CITY OF SANTA FE, NEW MEXICO
RESOLUTION NO. 2021-61

AMENDING THE MASTER PLAN FOR TIERRA CONTENTA TO INCLUDE MODIFICATIONS TO INFRASTRUCTURE, PARKS, TRAILS, LAND USES, AND DENSITY FOR PHASE 3A, WHICH CONSISTS OF PARCELS KNOWN AS TRACT 7A AS SHOWN IN BOOK 396, PAGE 014; LOT 8 AS SHOWN IN BOOK 396, PAGE 11; TRACT 9 AS SHOWN IN BOOK 231, PAGE 46; AND TRACT 8A3-7C AS SHOWN IN BOOK 738, PAGE 15, WITHIN SECTION 13 AND PACHECO GRANT, PROJECTED SECTION 11, T16N, R8E, N.M.P.M., COMPRISING AN AREA OF APPROXIMATELY 216.52 ACRES, LOCATED SOUTHWEST OF CAPITAL HIGH SCHOOL (CASE NO. 21-3818, TIERRA CONTENTA MASTER PLAN AMENDMENT #1 FOR PHASE 3A).

**City of Santa Fe
Planning Commission
Findings of Fact and Conclusions of Law**

EXHIBIT C
Technical Corrections
Case #2021-3818
Tierra Contenta Master Plan Amendment #1 for Phase 3A

PASEO DEL SOL STREET CROSS - SECTION: 72' RIGHT OF WAY

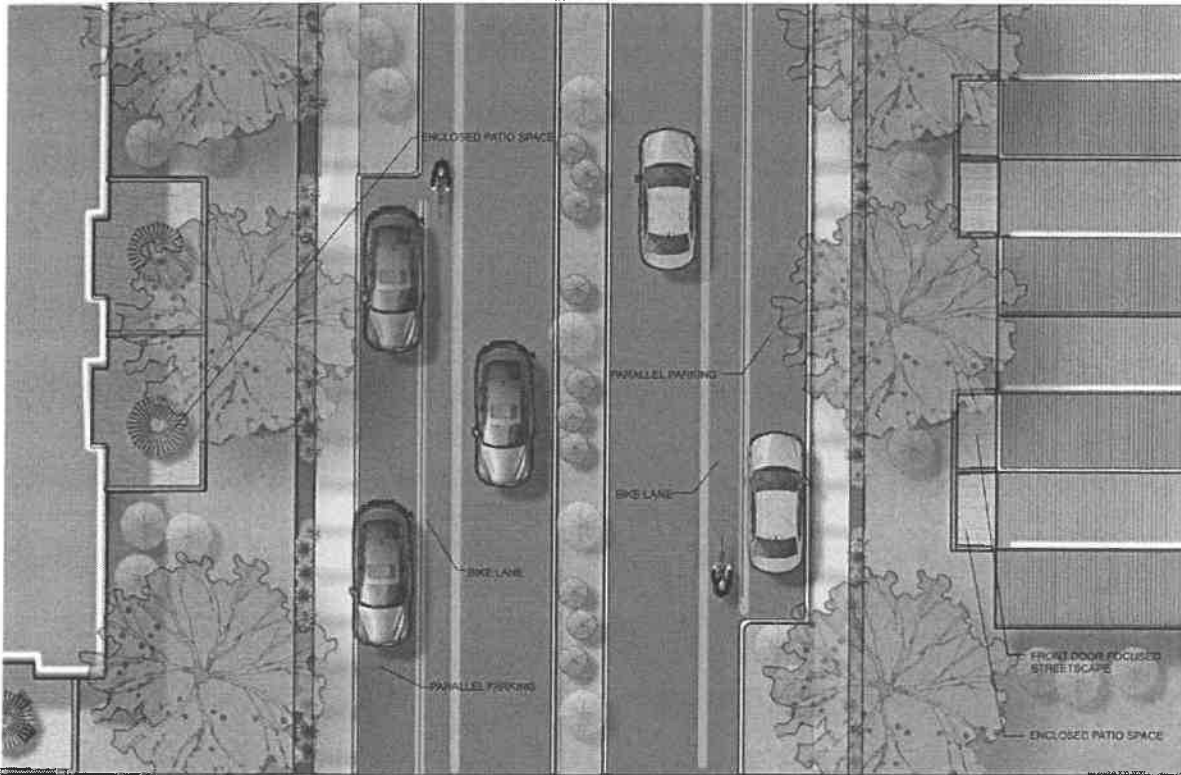
17	Include parking protected bike lanes as a design option	Land Use/MPO	Sheet Process
18	Widen the minimum sidewalk width to 6 feet along Paseo Del Sol, all other sidewalk widths shall comply with City Code.	Required by the Governing Body at the October 27, 2021, Governing Body Public Hearing	
19	Add a landscape buffer between all sidewalks and the road	Land Use/MPO	Sheet Process
20	Incorporate all conditions required for ADA compliance into the Master Plan Guidelines. ADA guidelines shall comply with both Federal and State ADA standards as amended.	Land Use/ADA Review	Prior to Recording

10. On October 27, 2021, the Governing Body amended the condition requiring 6-foot sidewalk widths affecting the Tierra Contenta Master Plan Amendment #1 for Phase 3A to 6-foot sidewalk widths along Paseo Del Sol, with the balance of sidewalk widths for Tierra Contenta Master Plan Amendment #1 for Phase 3A subject to City Code.
